ADDENDUM NO. 4

PUBLIC STAIRWAY **CONSTRUCTION PHASE**

BID #26-011
PAWTUCKET, RI

ISSUED: June 26, 2026

ELECTRICAL DETAILS - LIGHT FIXTURE TYPES

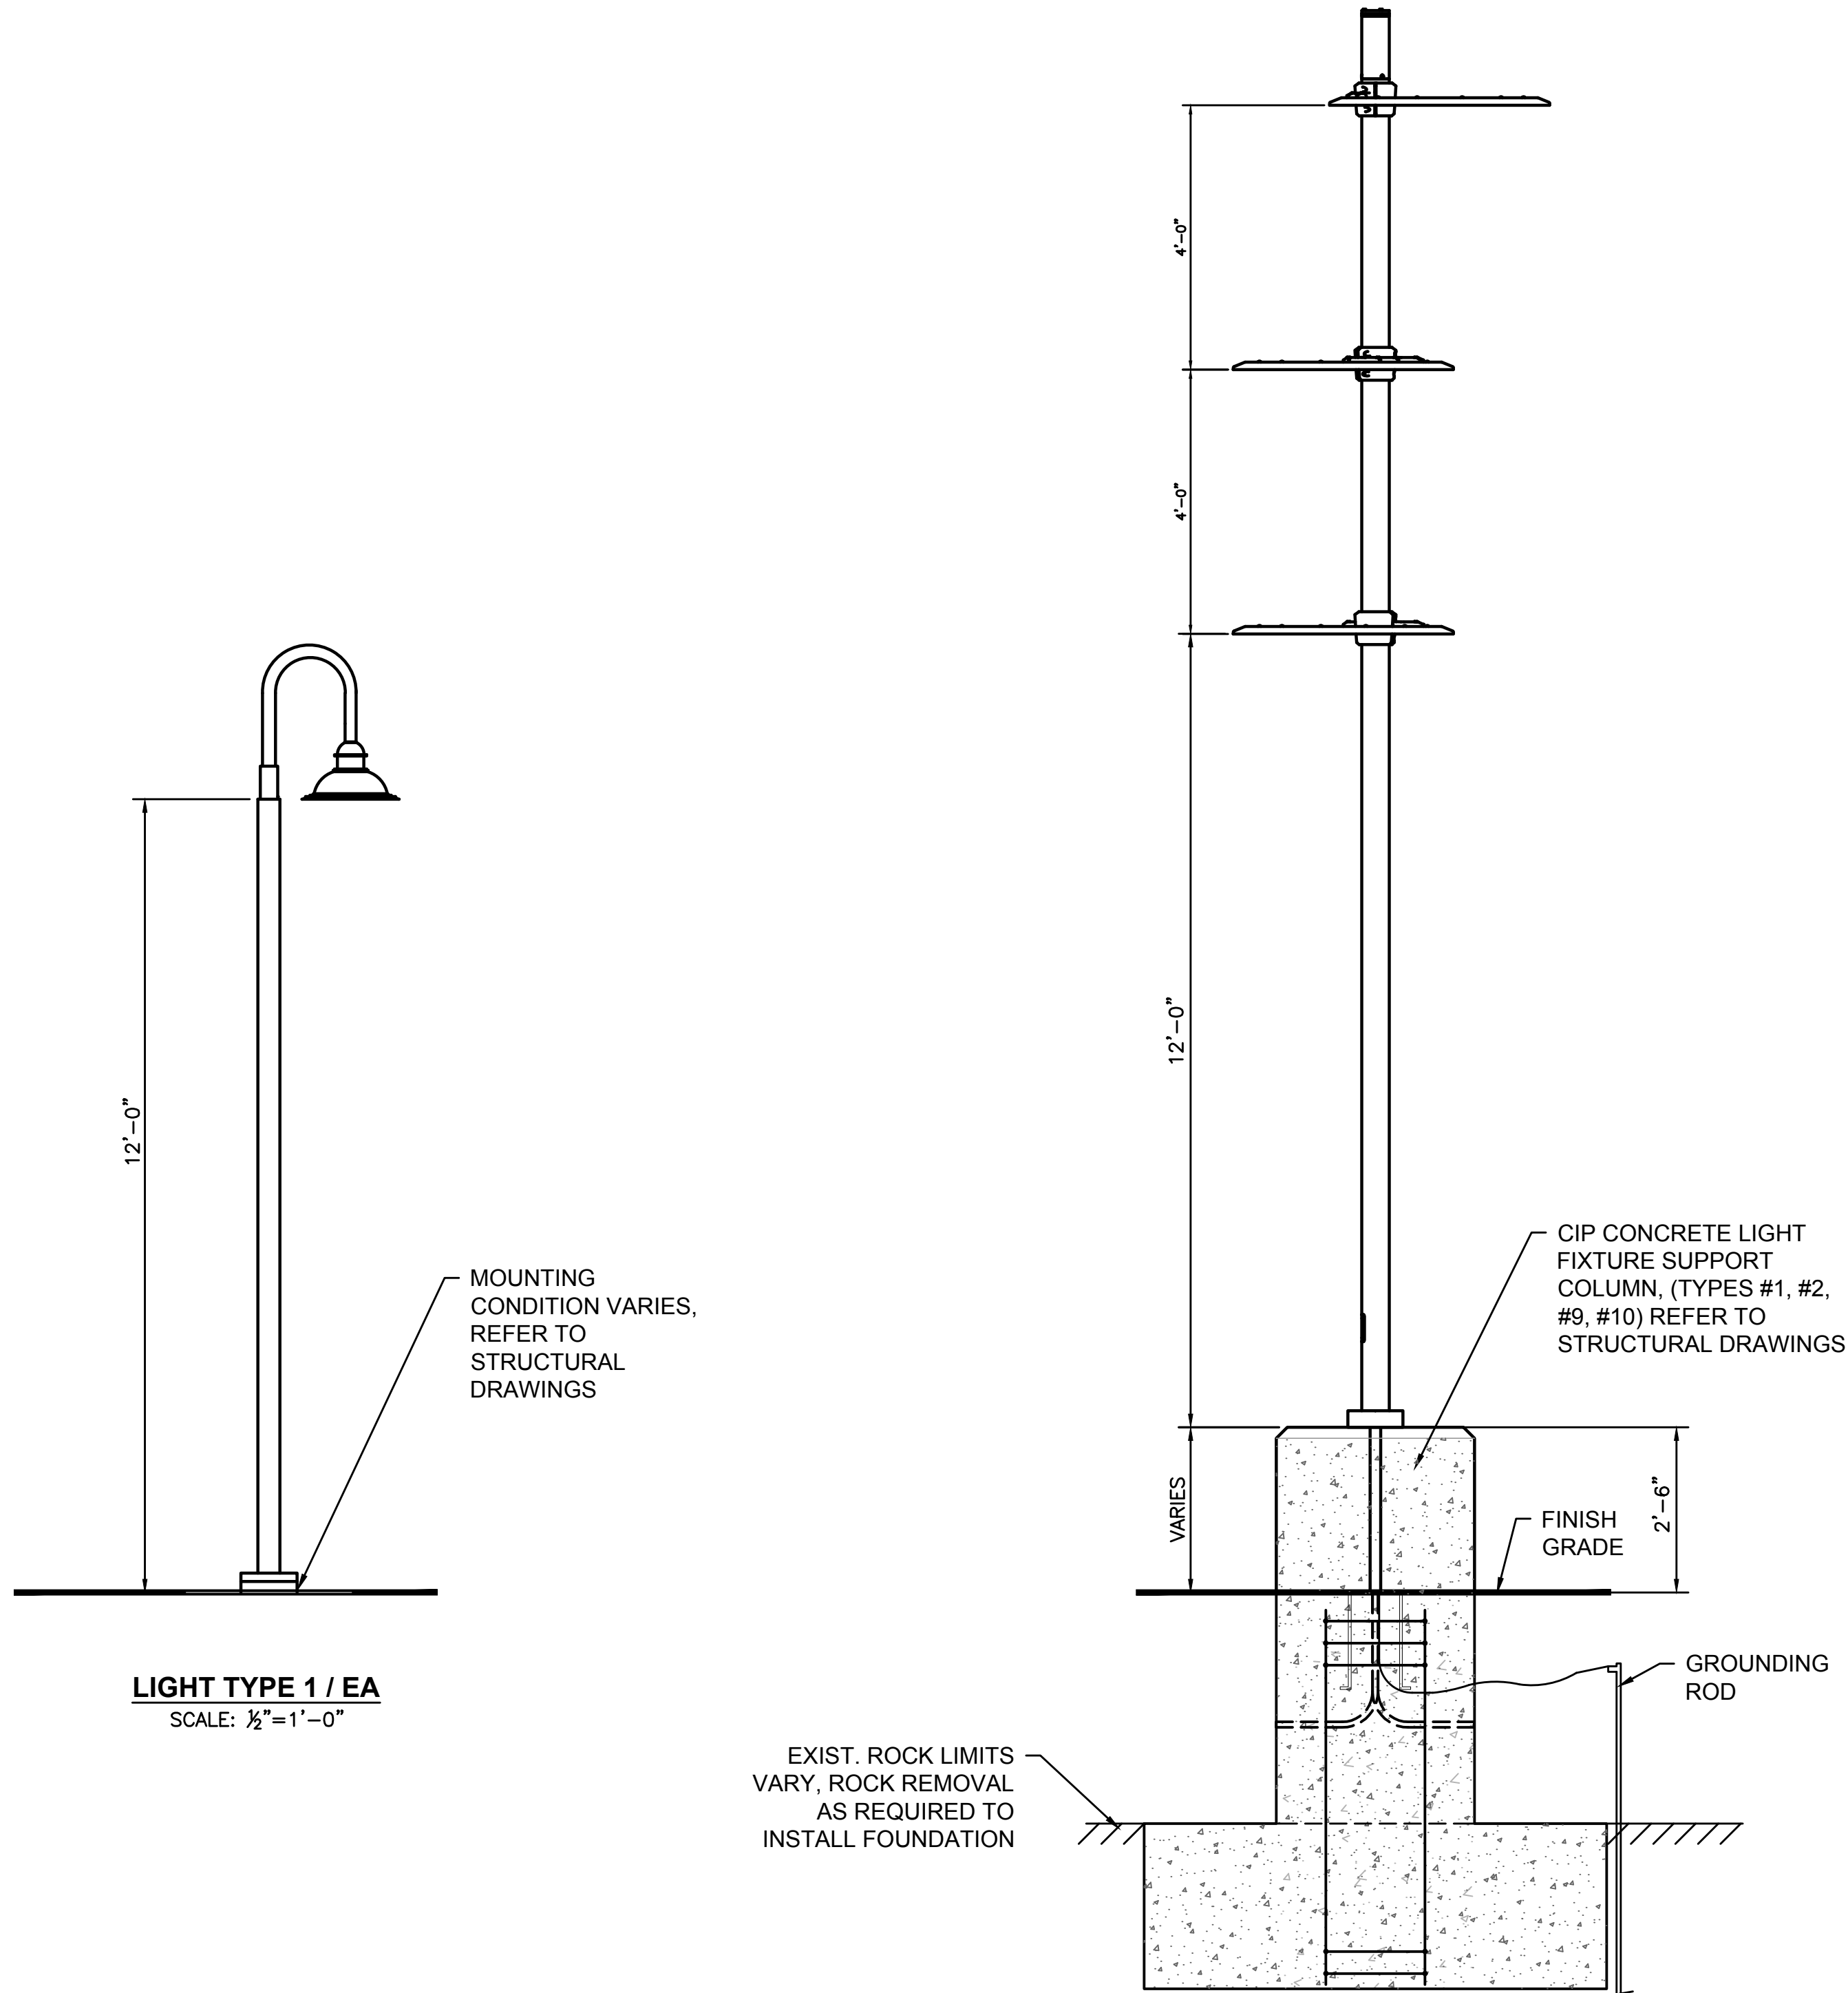
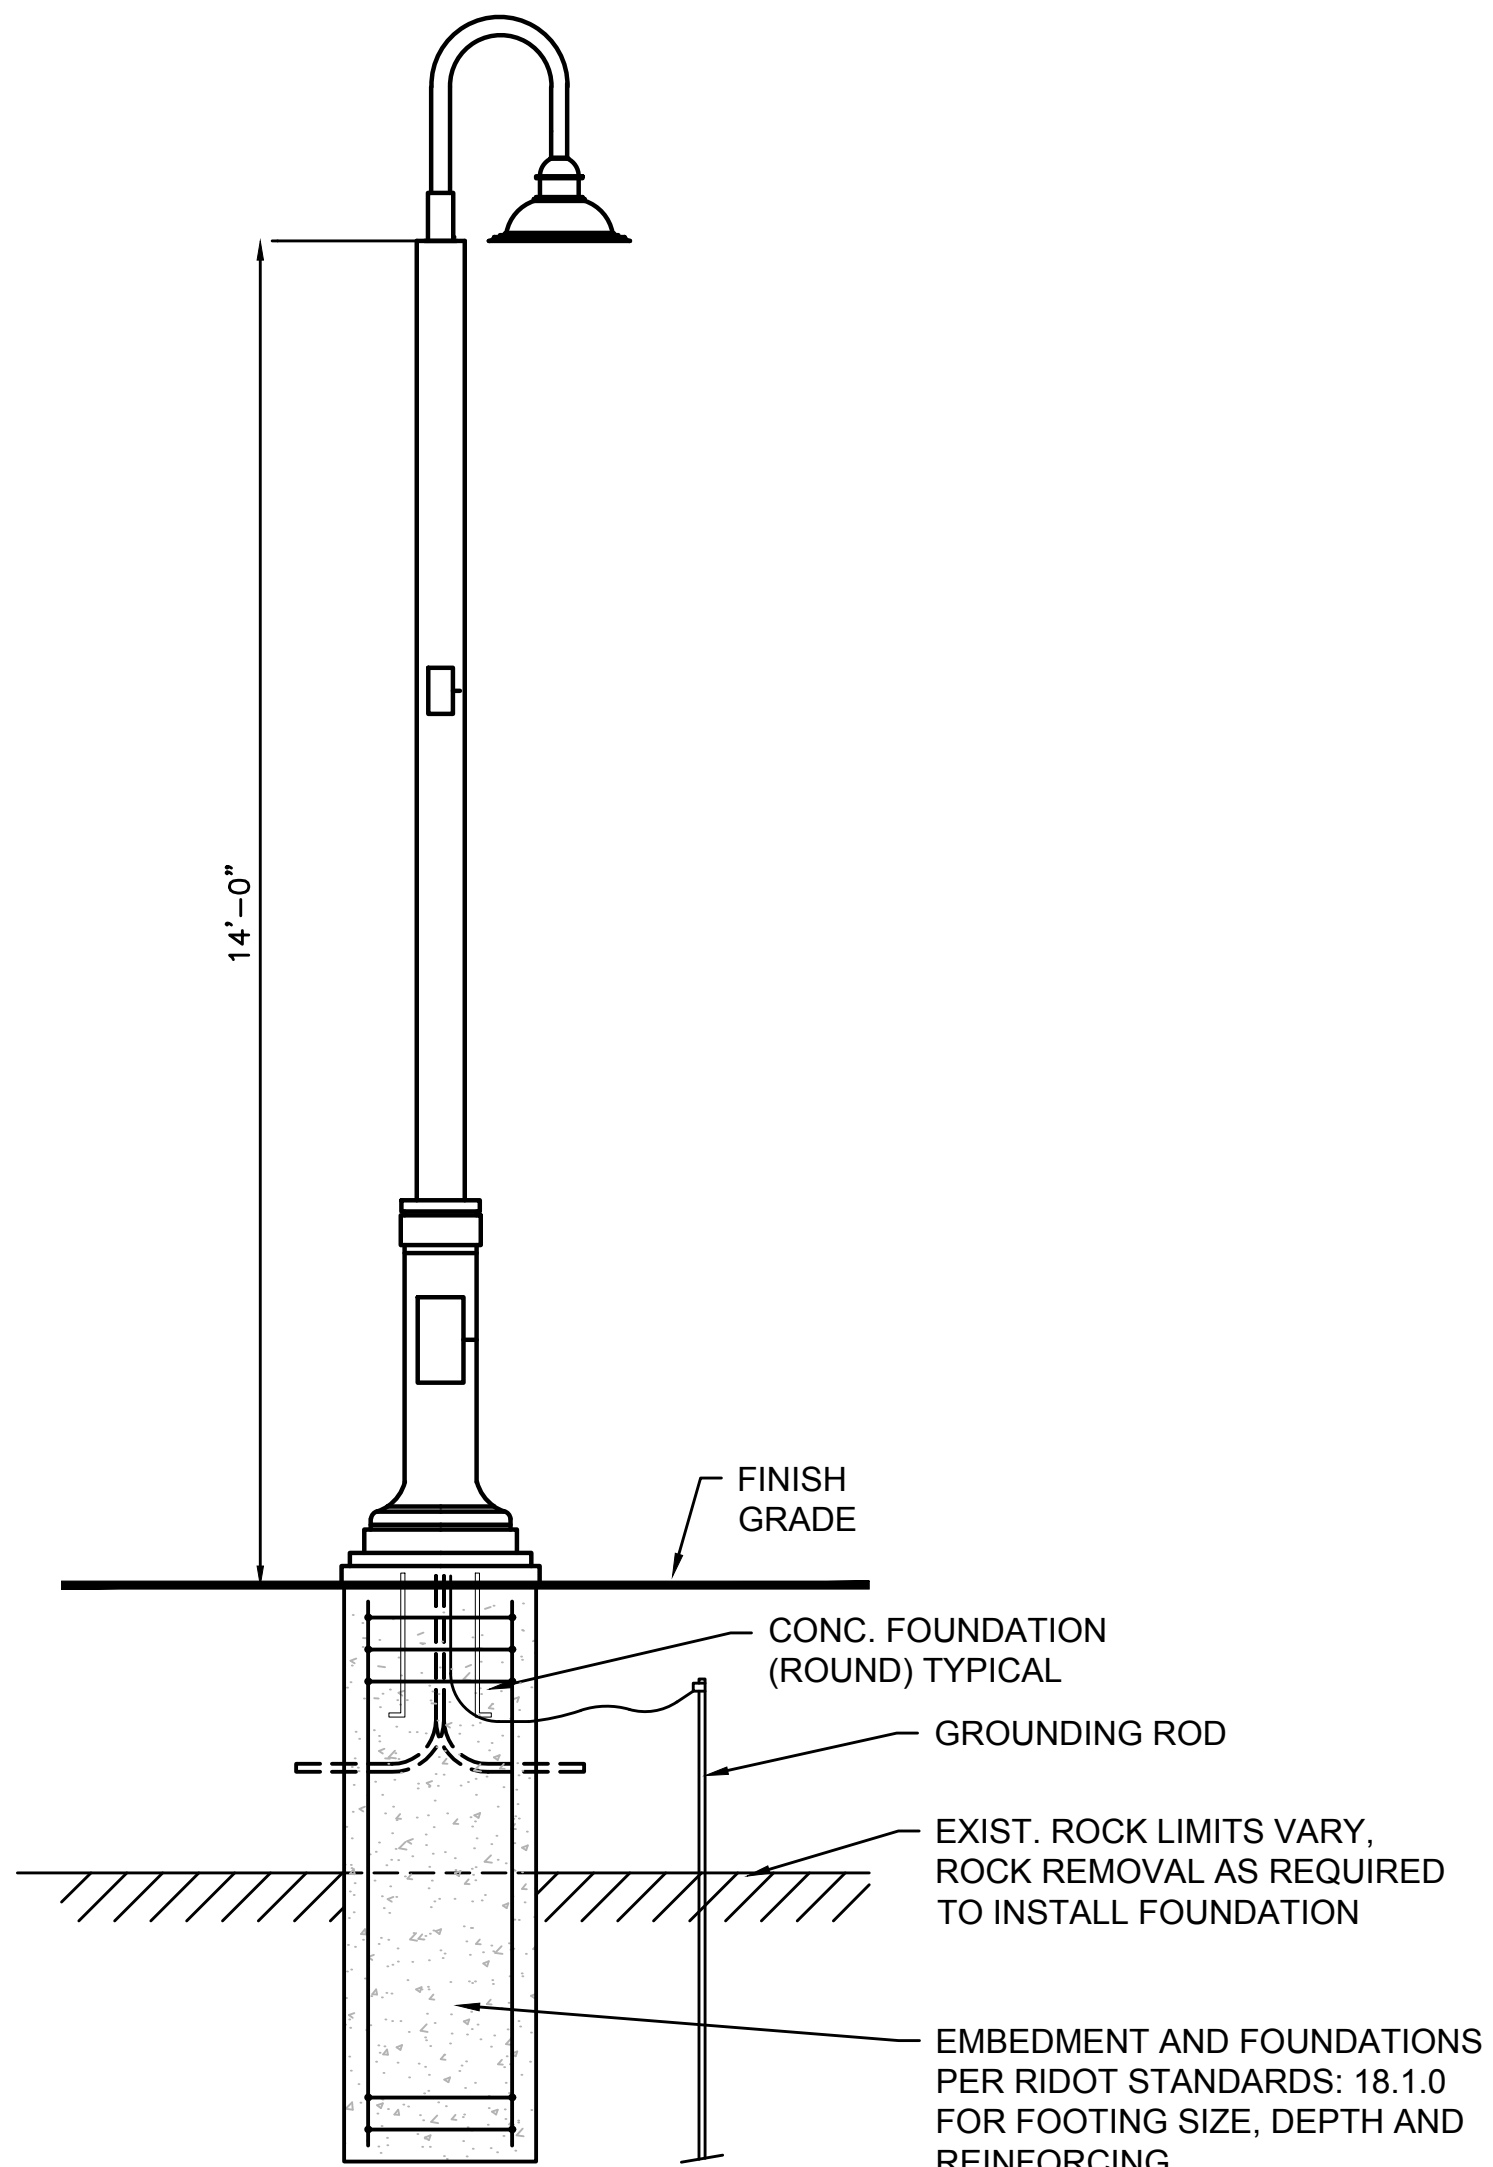
NOTE 1: PROVIDE 12' POLE, BRACKET ARM #DOS-DBA
NOTE 2: PROVIDE (3) LIGHT RINGS WITH 20' POLE
NOTE 3: PROVIDE 14' POLE, BRACKET ARM #DOS-DBA, AND PROVIDE GFI DUPLEX RECEPTACLE
NOTE 4: LIGHT TYPE 1/EA AND 3/EC SHALL MATCH THE OWNER SELECTION FOR THE CITY OF PAWTUCKET 26-012 RIVERWALK WEST PROJECT.
